Access Compliance Report

(Curb Ramps)

| Intersection ID: 8498 | Main Street: KENNEDY_ST | Cross Street: N_GRAHAM_ST | Location: SE |
| ADA ID: 02FF5D7236A4 | Ramp Type: Combination2 | Initial Pass/Fail: Fail | Overall Compliance: No |

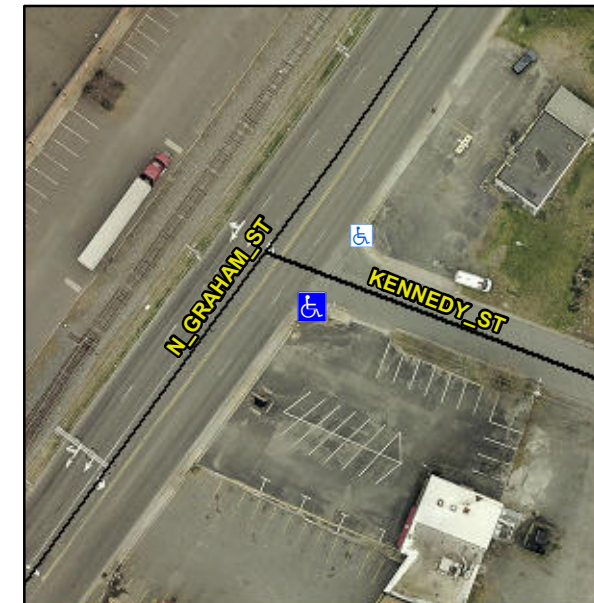
LT RP < 5%

Not Found, R304.5.1, R304.5.3

Remove & Replace Entire Ramp.
